**ONTARIO ENERGY BOARD**

**AND IN THE MATTER** of an application by Grand Renewable Wind LP for an Order or Orders granting Leave to Construct new Transmission Facilities within Haldimand County, Ontario.

**APPLICANT RESPONSE TO**  
**HALDIMAND COUNTY HYDRO INC. (“HCHI”) INTERROGATORIES**

**SCHEDULE A**  
**TYPICAL POLE CROSS SECTION**

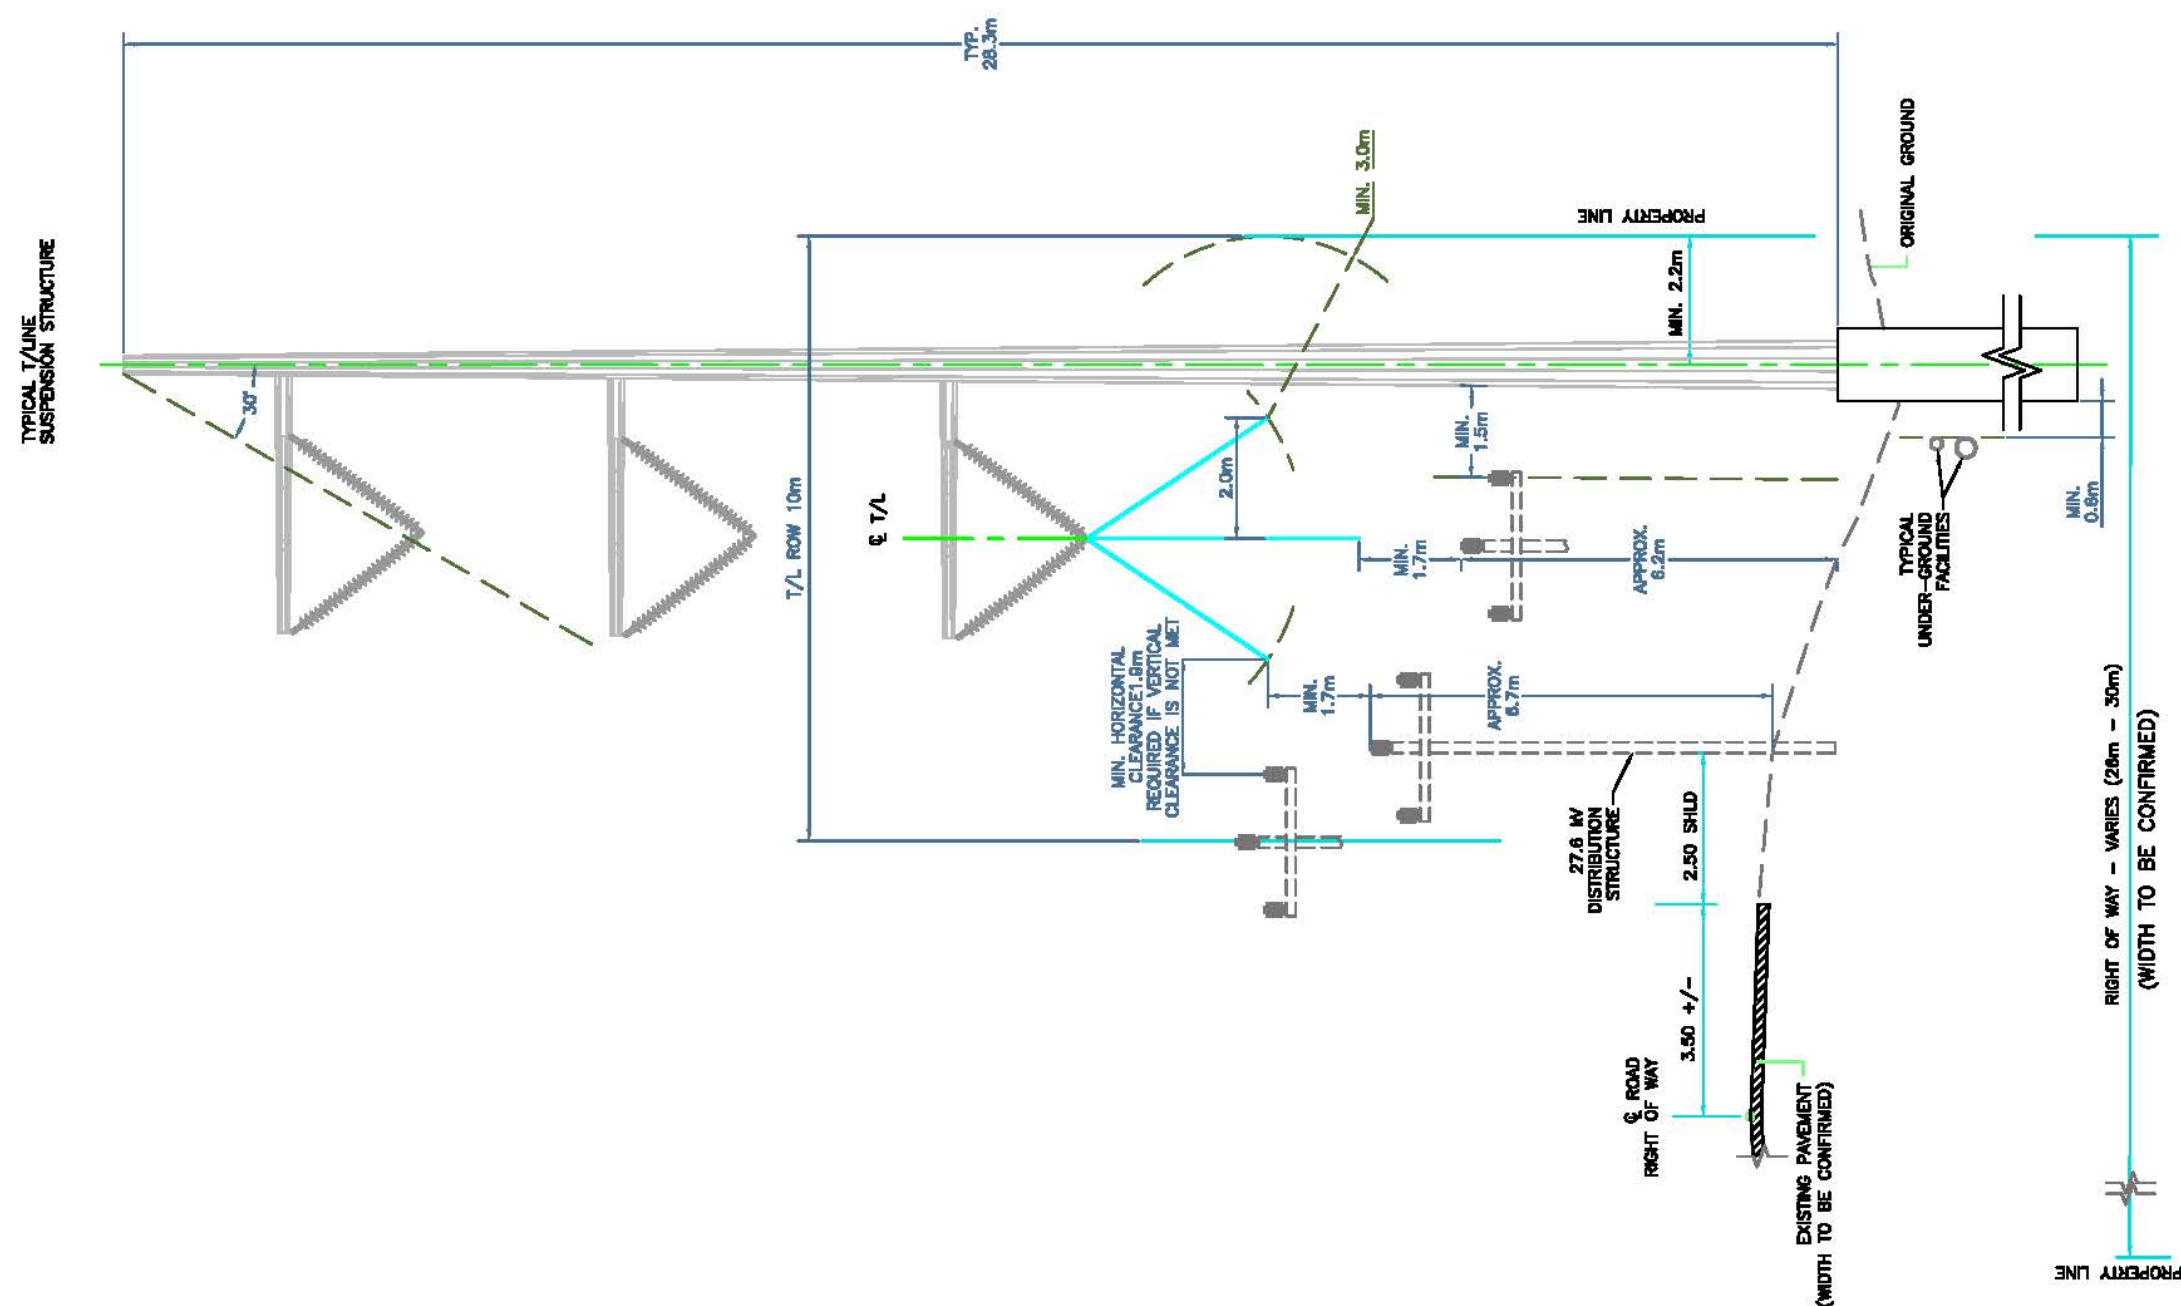
- (c) Has Grand Renewable determined where within the road allowance the proposed transmission line is to be located? If so, please provide a map, plan or description of the location including the side of the roadway on which it is to be located and distance from the travelled portion of the road, as well as the property line. If not, has Grand Renewable determined a minimum separation distance from HCHI's distribution system.

Please see cross section graphic (the "**Cross Section**") attached here to as **Schedule A** for the location of the Transmission Line within the road allowance, both overhead and underground configurations. The Cross Section shows the minimum and maximum location of poles relative to the property line. At a minimum, the poles will be located approximately 2.2 m from the property line and a maximum of 5.5 m (for a 30 m ROW) and 3.5 m (for a 26 m ROW). Note that the width of the right of way varies. The Applicant has confirmed with the County's planning department the accuracy of the ROW widths for the entirety of the Transmission Line Route.

The position of the Transmission Line within the ROW will ensure a minimum clearance from the driving surface of the road to the Transmission Line poles of 6m. The preliminary design also shows that 2.2 m minimum clearance is required from the structure to the property line. The width of the ROW will vary depending on the span length although it is normal practice to establish a maximum ROW and use this width for the entire length of line. The structure position within the ROW will depend on the position of existing utilities both overhead and underground and any construction

### TYPICAL UNDERGROUND CROSS-SECTION

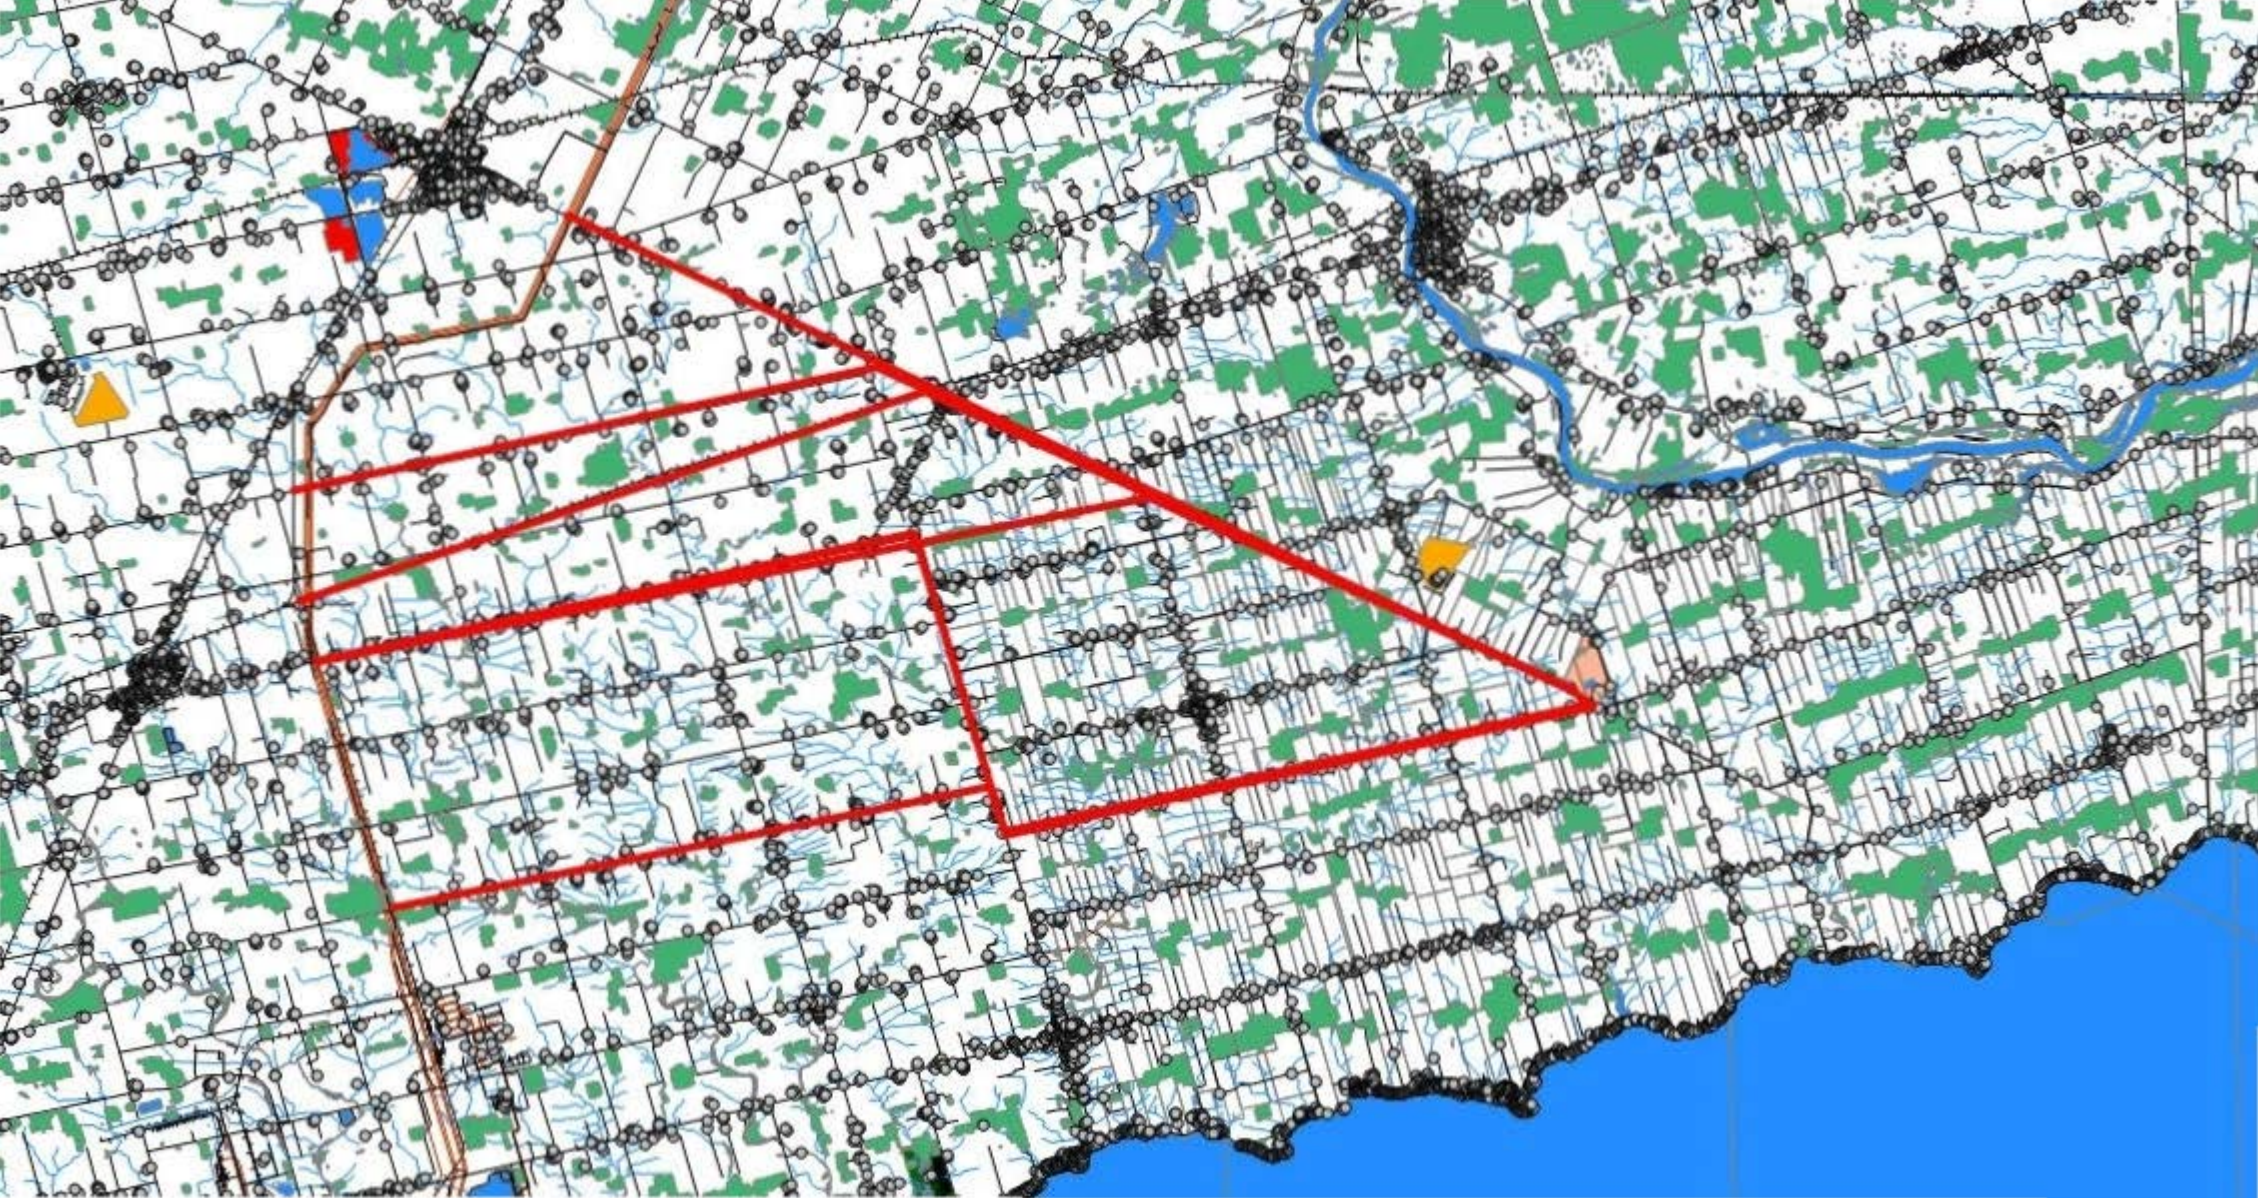
- (h) How does the location of the easement relate to the right-of-way (i.e. does it extend beyond the right-of-way)? Please provide a cross-section of the right-of-way showing the proposed location of the easement and the location of the transmission line. Please show for both the above ground and underground sections of the transmission line.

For the underground section of 230 kV line, the ROW required is normally dictated by the working space required to excavate and install the concrete duct bank, this in turn is dictated to the layout of the duct bank i.e. horizontal versus vertical formation, spare cable and communication cable requirements and depth of installation. The installation can be positioned closer to the road surface and adjacent to the shoulder so that installation can be carried out from the road. As an example, for a vertical duct bank consisting of 3 cables plus one spare plus up to two OPGW communication cables, the required ROW can be as little as 1.0 m if installation and maintenance can be carried out from the road.

The easement for the Transmission Line will be contained within the road ROW for both overhead and underground sections.

**FOUNDATIONS UNDER CONSIDERATION**

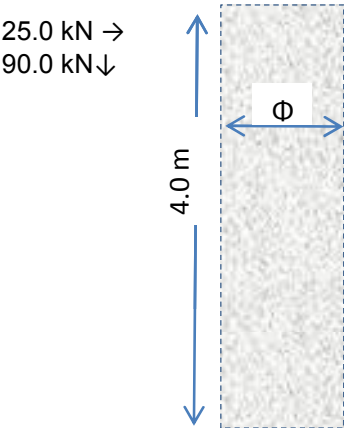
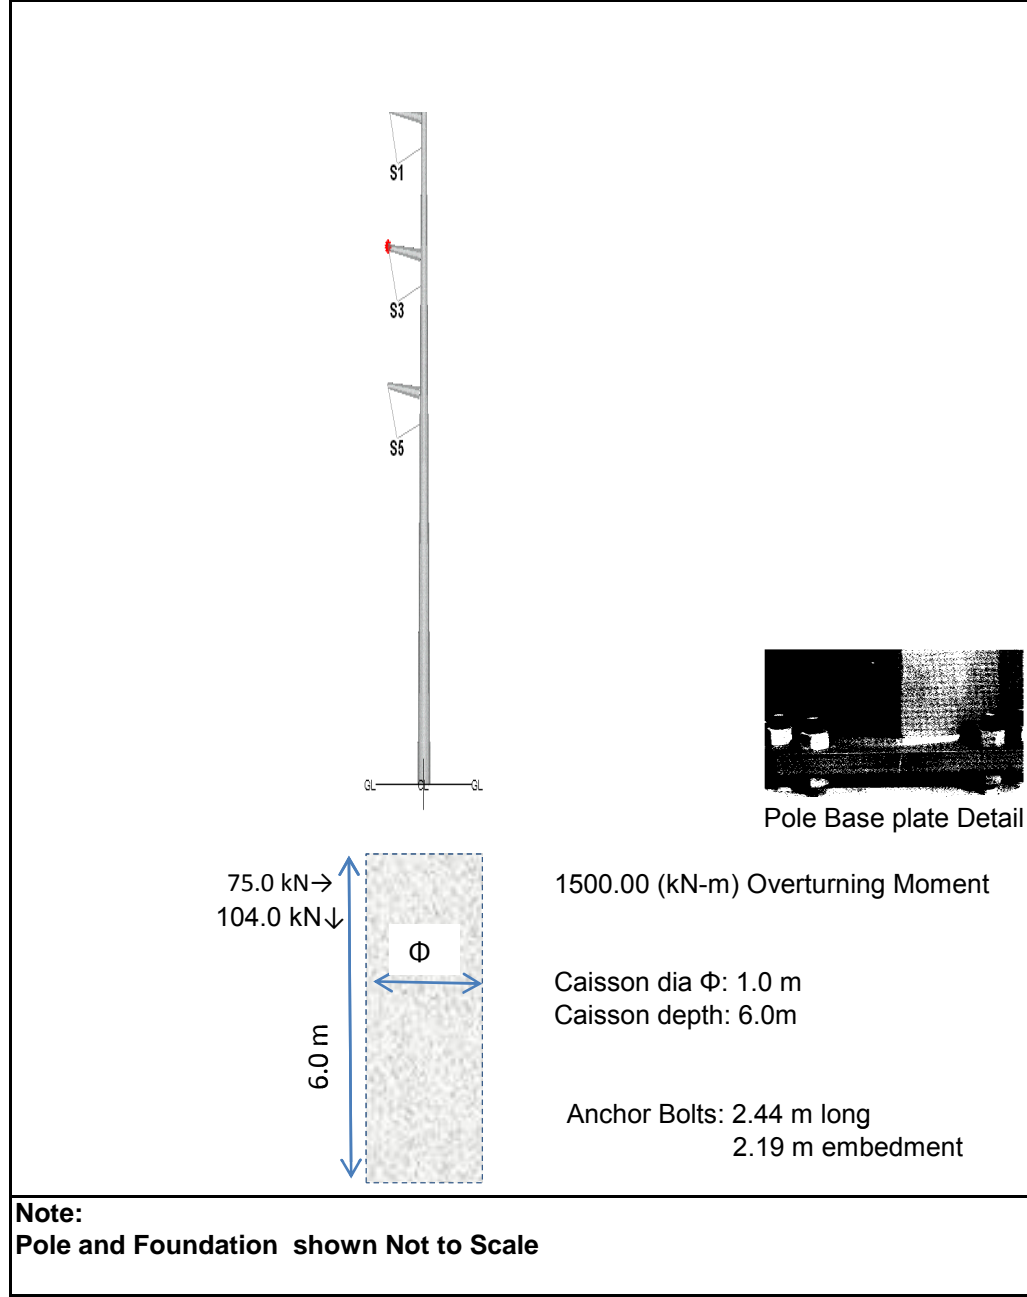
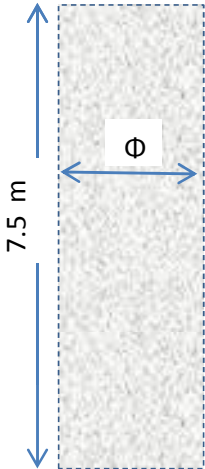
(i) How large are the concrete foundation for the proposed poles?

The Applicant is considering three types of foundations, each of which is attached hereto in **Schedule F**. The type of pole foundation used will be dependent on line stresses.
